# Preferred Project Report and Statement of Commitments

## Neuroscience Research Precinct

Major Projects MP 08\_0086 and MP 08\_0153

Submitted to  
Department of Planning  
On Behalf of Prince of Wales Medical Research Institute Ltd

**Figure 1** – Barker Street elevation

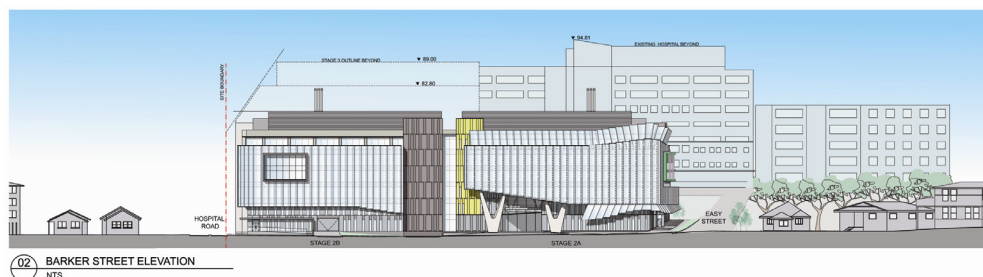
**Figures 1 and 2** illustrate the relative height and bulk of the proposed Stage 2 development and the Stage 3 building envelopes in comparison to the adjoining residential buildings to the west, and hospital buildings to the north and west of the site. These figures also illustrate the extent to which the proposed Project Application development relates to the proposed Concept Plan building envelope for Stage 2.

Based on these figures and the amended architectural plans (included in **Volume 2**), the bulk and scale of the revised development as a whole is considered to be in context with the adjoining hospital buildings given that:

**Figure 4** – Pedestrian and vehicle access pathways in and around the site

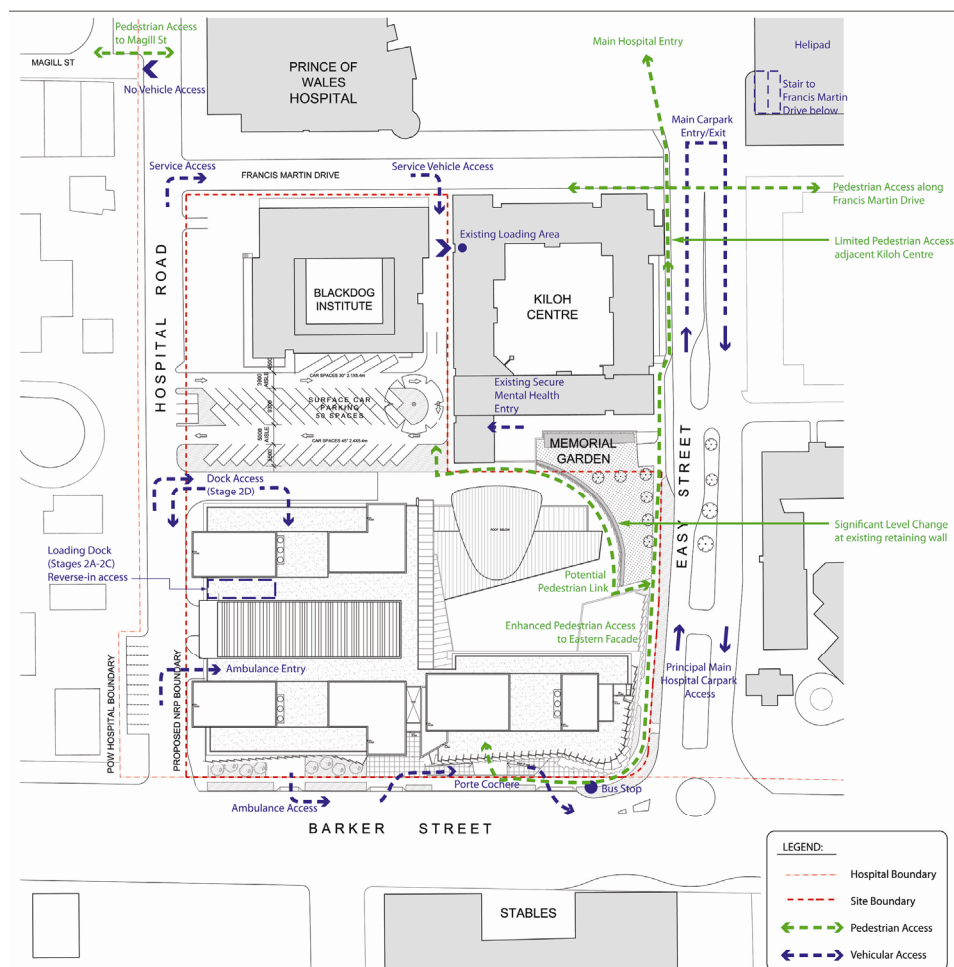
Council's submission has recommended the development provide specific through site links to improve pedestrian amenity and improve pedestrian links between the main hospital buildings and the institute. Specifically Council recommends including:

- an east west site link through the site, just to the south of the Kiloh Centre, which would provide a direct pedestrian link between Hospital Road and Easy Street; and
- a pedestrian link from the Stage 3 development to the main hospital buildings to the north, crossing over Francis Martin Drive.

Cox Richardson Architects has assessed the feasibility of the above and provided a diagram to illustrate site opportunities and constraints– see **Figure 4** and Pedestrian and Vehicular Access Illustration at **Appendix E**.

The provision of a site link through the middle of the site between Hospital Road and Easy Street is not considered feasible or practical on the basis that this outcome:

- could bring about potential conflict between pedestrians travelling along this path and truck movements to and from the loading dock at the rear of Stage 2D;
- would result in a pathway with a significant level change from Hospital Road up to Easy Street, which may not be able to provide equitable access or would require significant treatments and use of switch back ramps, or the like;
- may allow for inappropriate public exposure and interface with the Black Dog Institute and Kiloh Centre, where patients are treated for depression and mental health issues;
- would not facilitate a direct link as the pathway would have to be redirected around the memorial garden, located to the south of the Kiloh Centre; and
- can readily be achieved with pedestrians travelling along Barker Street, which is only 35 metres south of the suggested pedestrian link.
